THREE MILE ISLAND NUCLEAR STATION, UNIT NO. 1

AMENDMENT TO FACILITY OPERATING LICENSE

Amendment No. 58  
License No. DPR-50

ATTACHMENT TO LICENSE AMENDMENT NO. 58

FIGURE 6-1

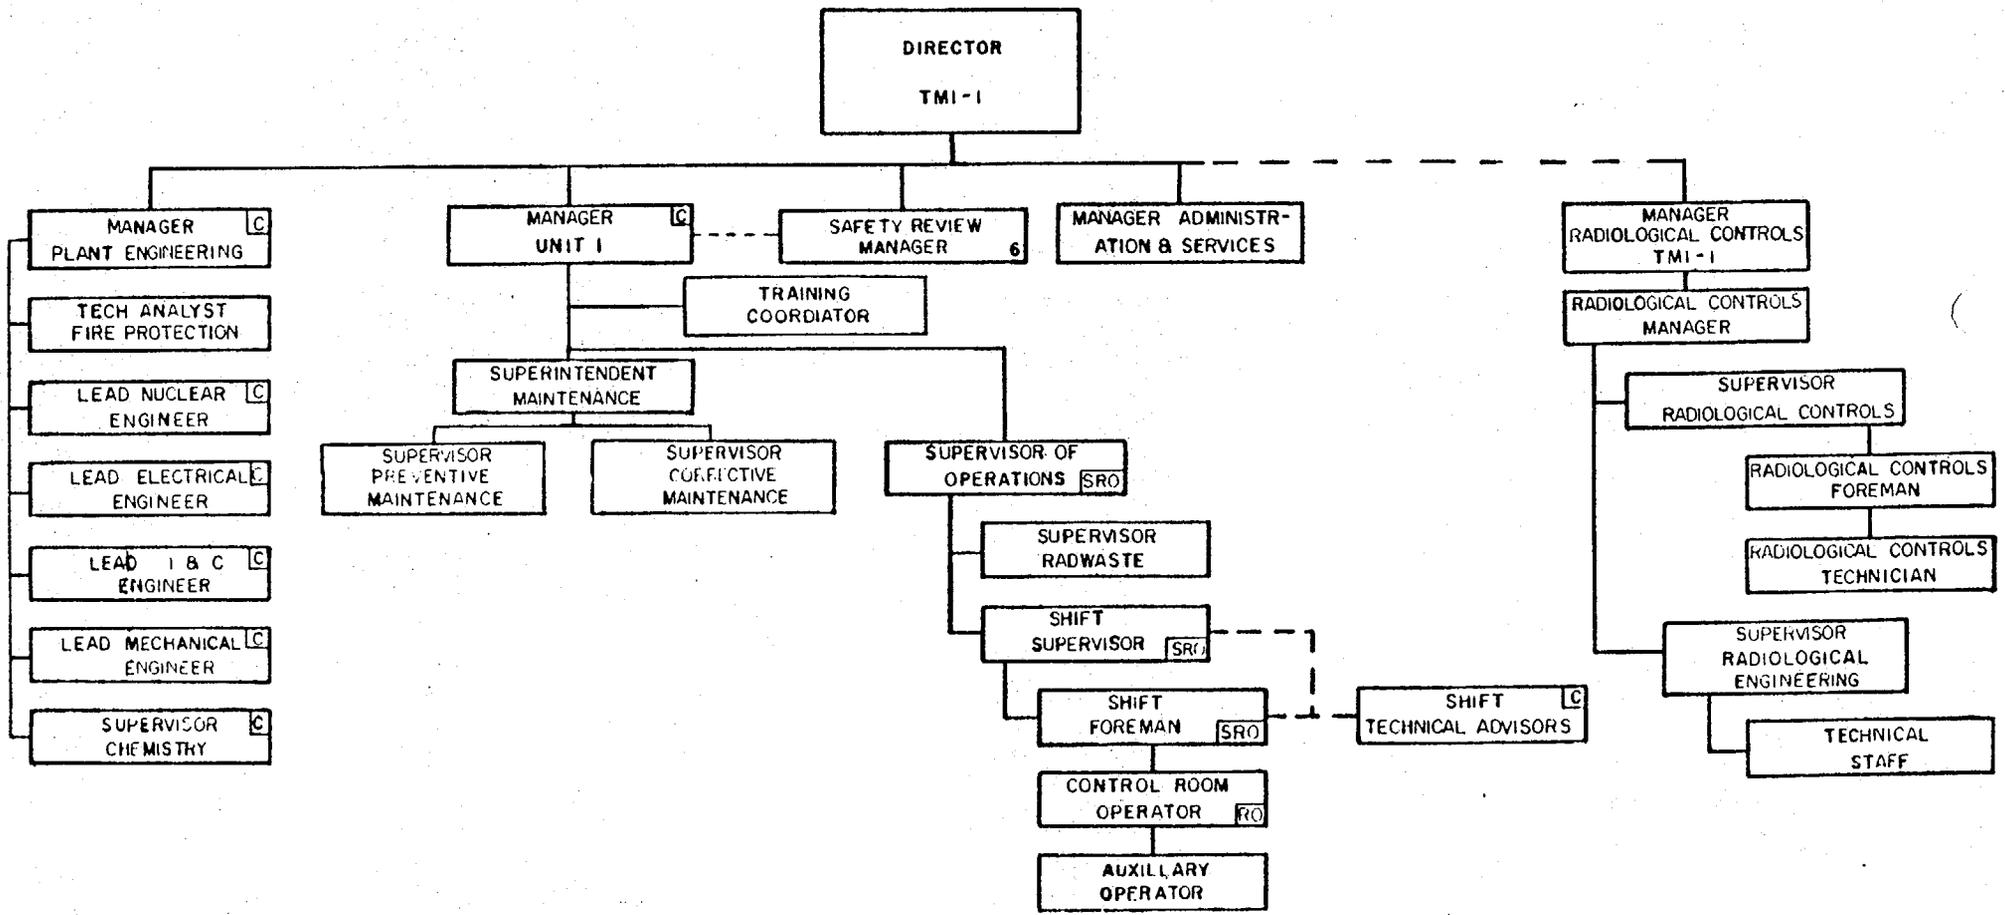
Figure 6-1 of Appendix A

Figure 6-1 Onsite Organization

**FIGURE 6-1**  
**ORGANIZATION CHART**  
**GPU NUCLEAR GROUP**<sup>1,2</sup>

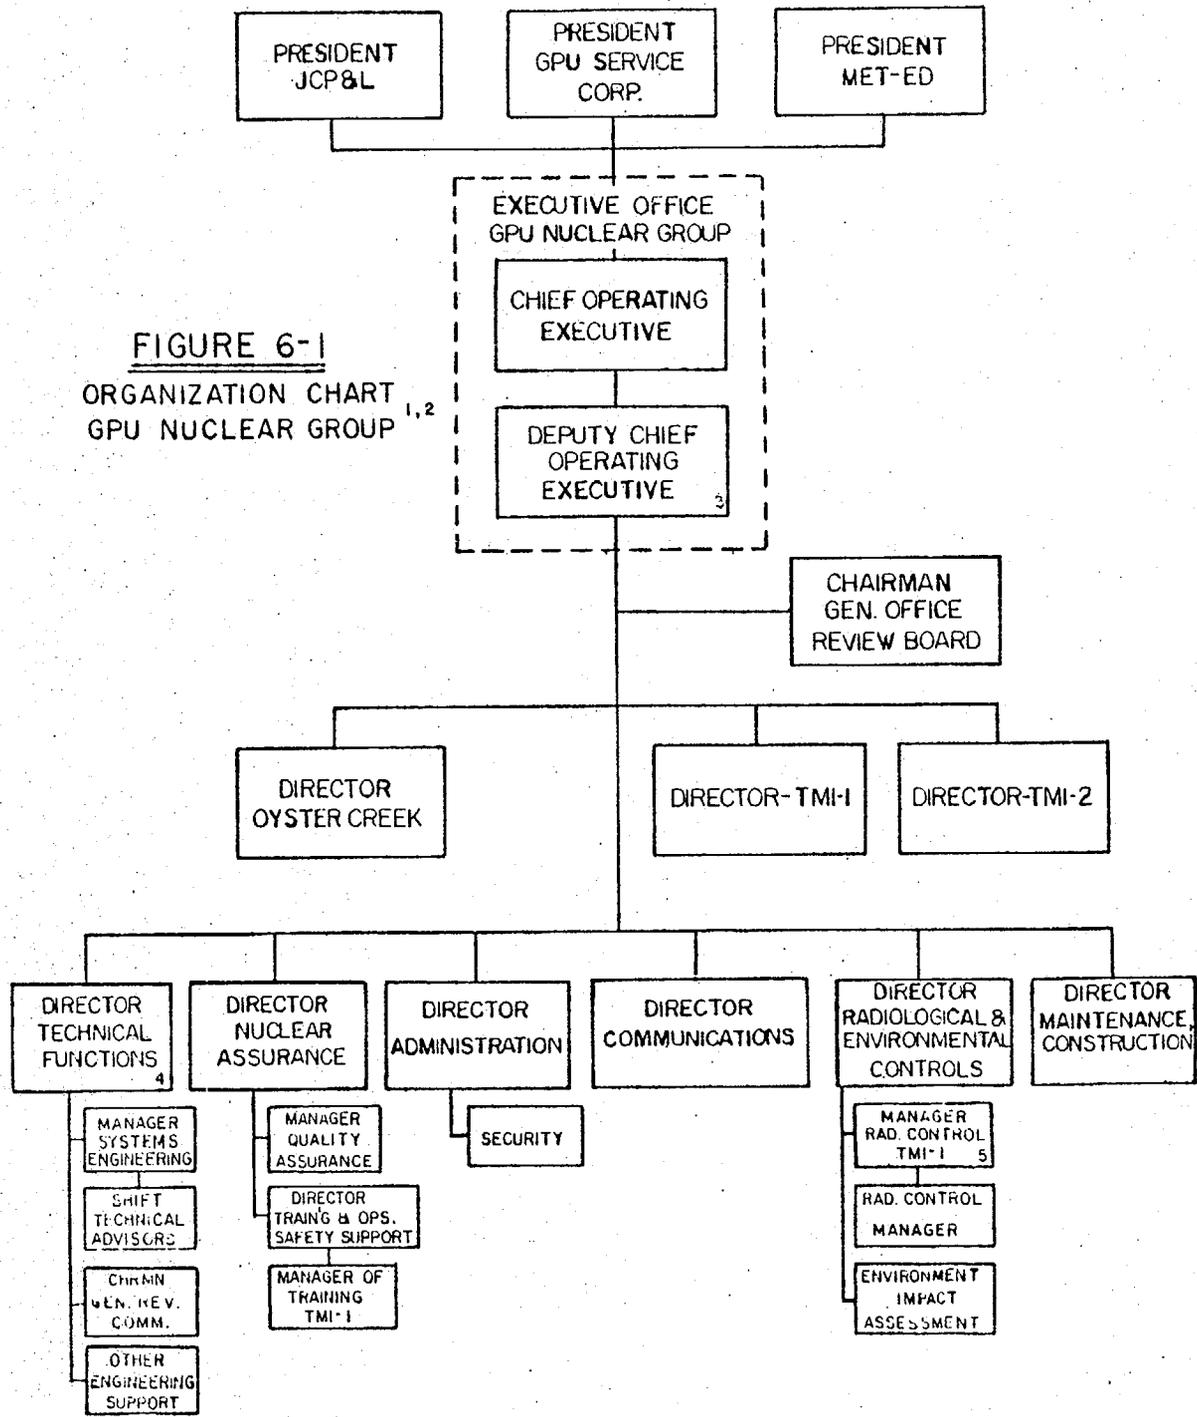
Figure 6-1 Organization Chart  
GPUNC

Position Notes

1. The following GPU Nuclear Group positions have responsibilities and authorities equivalent to those positions set forth throughout Section 6 and are as follows:

2. The following titles have no direct equivalents in Section 6 but have significant responsibility in the GPU Nuclear Group.

3. The Deputy Chief Operating Executive shall have the same authority to direct actions and assure compliance with Technical Specifications as the Chief Operating Executive.
4. The responsibility for independent review shall be assigned in writing to the Chairman of the Generation Review Committee (full time position).
5. In accordance with the Radiation Protection Plan, the Manager Radiological Controls or his deputy (Radiological Controls Manager if assigned) shall meet or exceed the requirements of Reg Guide 1.8, September 1975.
6. The Safety Review Manager is the full time Chairman of the PORC.
